OLMSTED BROTHERS

separate cover to night a blue print showing a study only partially completed - of suggested treatment

of Date St Entrance and bridge to central mesa - and bridge across Spanish Canyon to central Park Boulevard -

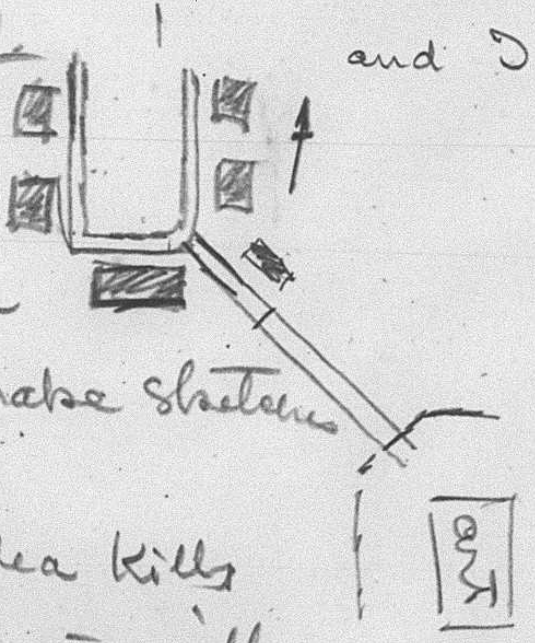
to you — I <sup>was</sup> anxious to get <sup>(2)</sup>  
this print off to you to night —  
so have not given it the amount of  
study it should have — in fact I  
already see that to save fill and  
to get cut material — the Spanish  
Canyon bdy should be moved at  
least its own width further  
north — and the drains on the central  
Mesa W. of Spanish Bdy should be  
lowered to get material —

The south ~~end~~ portion of the  
Date St Plaza — main seems to  
narrow — with only 35' roads  
on each side of a central 60 parking  
I had these roads 50' wide first and  
then thought that the side walls  
on the south side of Date St going  
to the water would have to remain so  
have shown a platg strip 15' wide  
out side of the present curb —

If we make these two roads 50' wide -  
 I am ~~feared~~ <sup>proportion of</sup> it will shorten too much  
 the long plaza going north -  
 perhaps not - This need more study  
 but what I am anxious ~~for~~ to do  
 is to establish and get your approval  
 in general of the plaza and more  
 especially the location of the long  
 bridge across Cabrillo Canyon -  
 The blue print is poor - I am sorry -  
 and will be hard for you to see  
 easily - grade  $\frac{1}{2}$  of approach from  
 N. end of long Plaza to bridge  
 2-3% - grade of bridge 2% -  
 grade <sup>at</sup> on N. E. end of Cabrillo  
 Bldg - to lot of drive to Spanish Bldg  
 3% - 4% and 5% - This should be  
 lessened ~~and~~ to get material -  
 Cabrillo Bldg 55' long - not including  
 the walls retaining a 15' fill at  
 each end - which has been allowed

Spanish Bridge as now proposed  
355' long - grade level - ②10  
will be slightly longer if it is moved  
it own width north and it may  
be that the el. can be raised to 212±  
from 210 as shown - This will  
increase cost - may be too much  
but it lessen grade of road between  
E. end and Park Baul. (axis of Exp.)
